DISTRICT 4 ROAD SAFETY AUDIT REPORT

SOMERSET CANYONS ACADEMY SR-804 (BOYNTON BEACH BOULEVARD) FROM SR-7 (US-441) TO LYONS ROAD

PREPARED FOR:
FLORIDA DEPARTMENT OF TRANSPORTATION, DISTRICT 4

FIGURE A1: EXISTING CROSSWALK

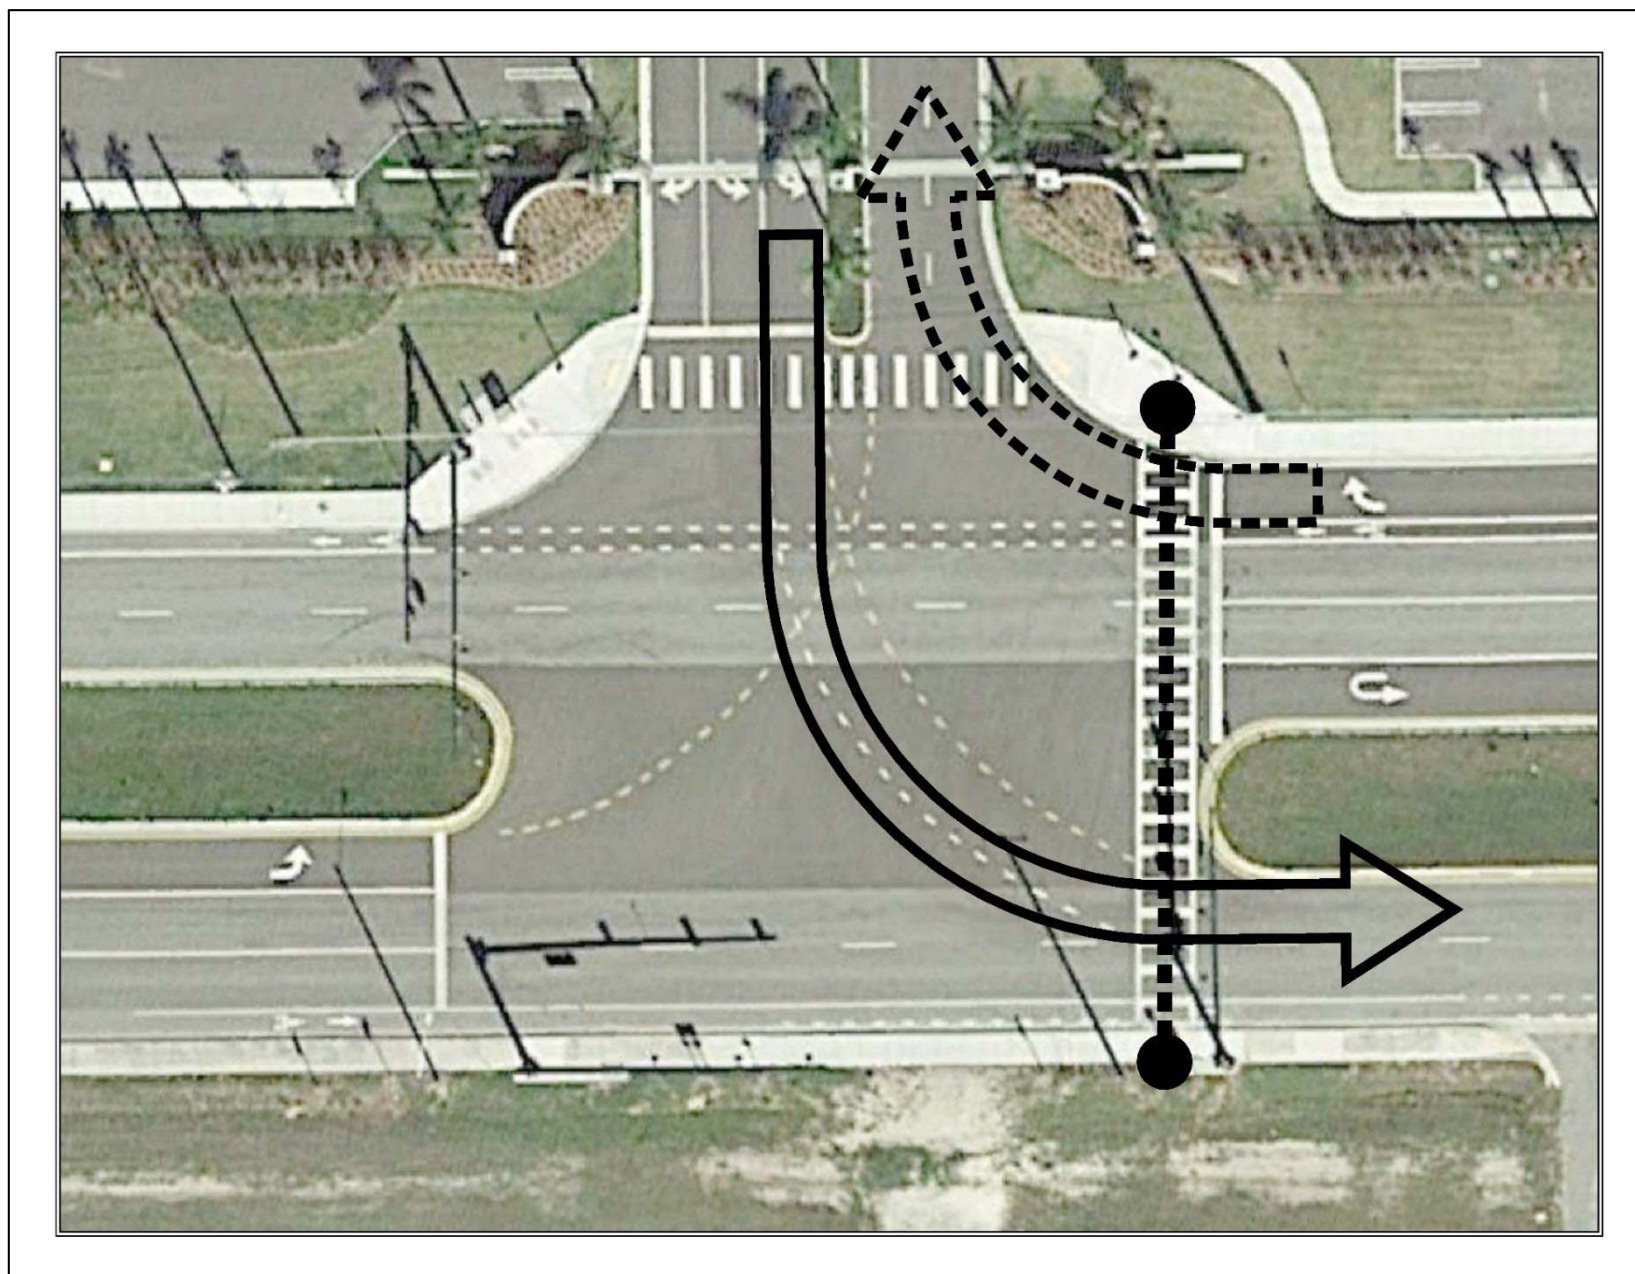
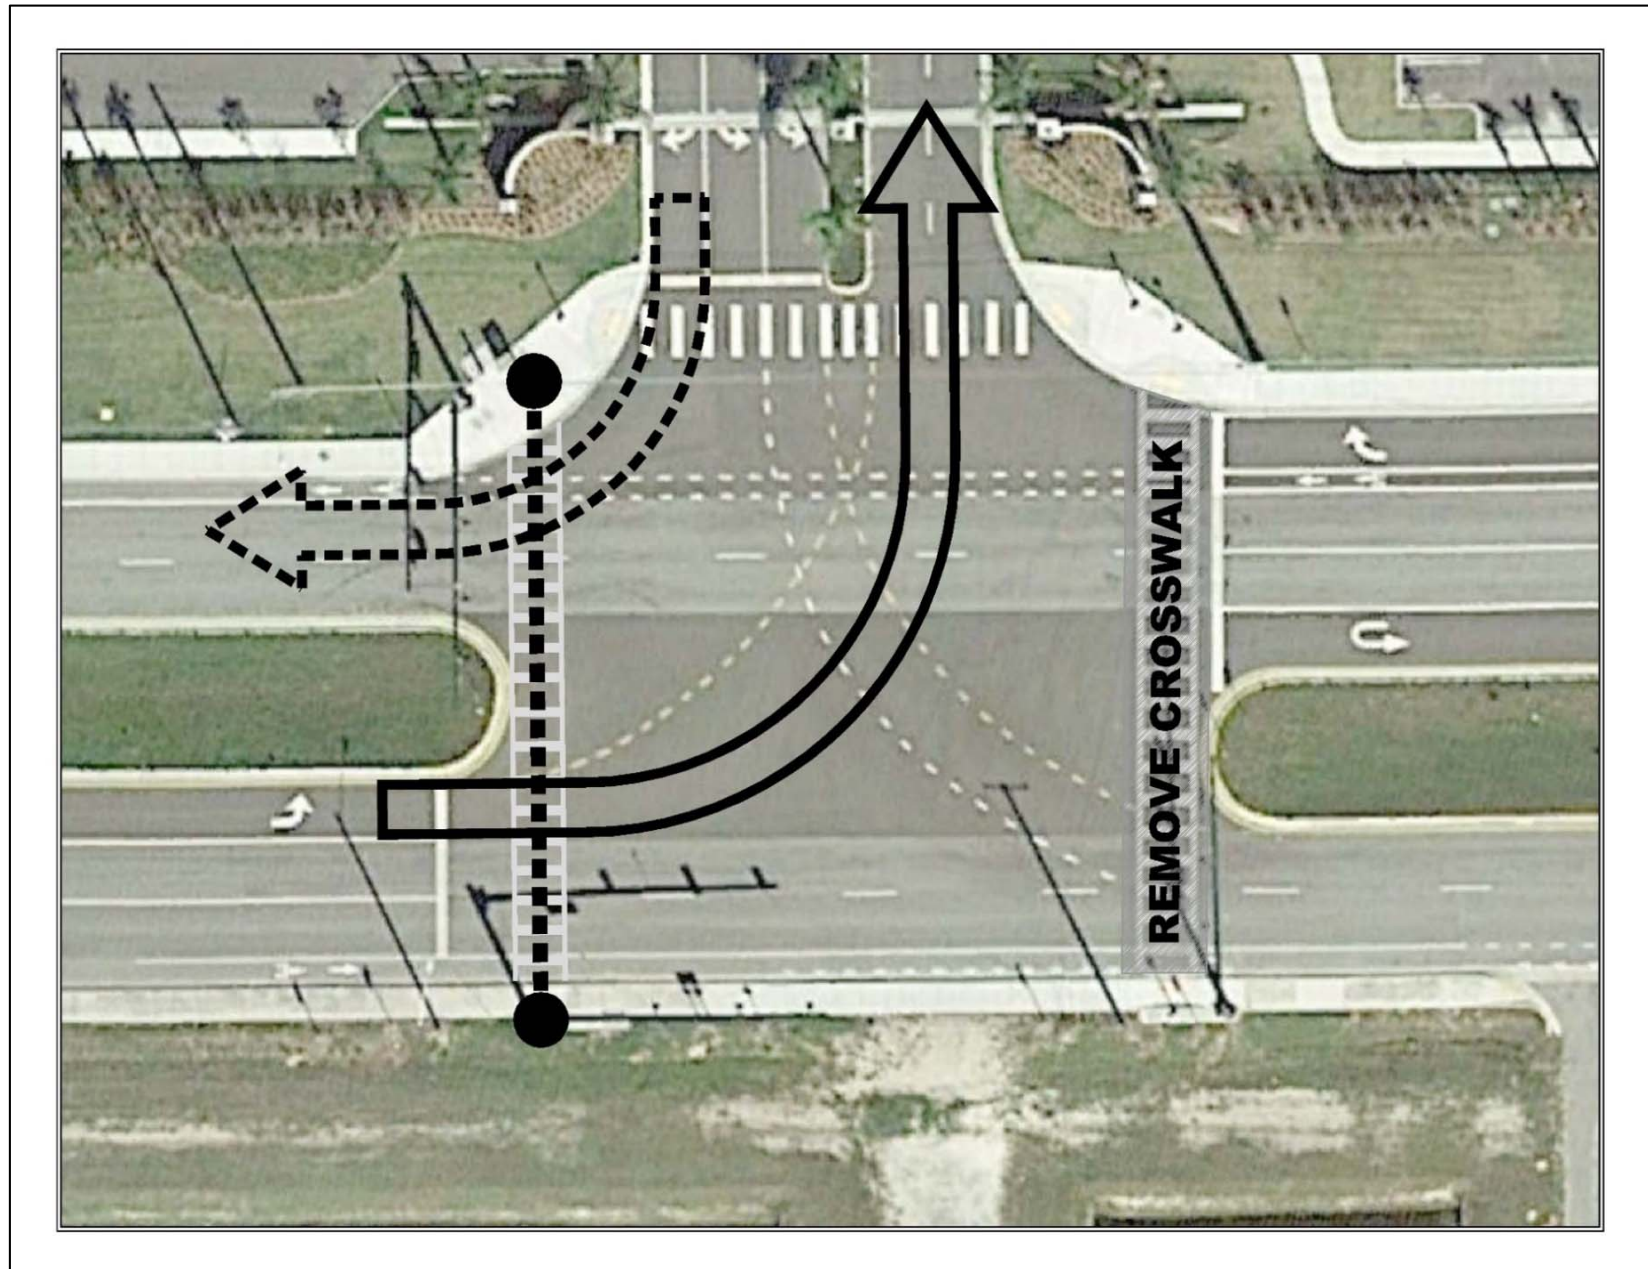
There is a crosswalk on the east leg of the Somerset Canyons Academy driveway crossing SR-804 (Boynton Beach Boulevard). In the PM peak, there is significant westbound right-turning traffic generated by cars entering the school for pickup. Many of these movements are made as "right turn on red," which directly conflicts with the protected pedestrian phase. In addition, these right-turning vehicles are in conflict with students walking from the school, through the driveway, to the northeast quadrant of the intersection. In addition, the pedestrian phase cannot operate when the southbound left-turn phase from the school is green. It should be noted that it is estimated that 70-80% of school traffic is executing these movements (to/from the east).

Consider relocating the crosswalk to the west side of the Somerset Canyons Academy driveway. In conjunction with this, provide an on-site gated sidewalk access to this quadrant. Review the potential to provide a sidewalk through the planter on the west side of the property at the location of the existing on-site crosswalk. This sidewalk would connect, through a gate, to the northwest quadrant of the signalized intersection. Note, also, there is an existing street light along this potential crossing and not at the existing crossing. The relocated crossing would reduce the pedestrian/vehicle conflicts at the signalized intersection and within the driveway. See Appendix Figure 1 and Figure 2.
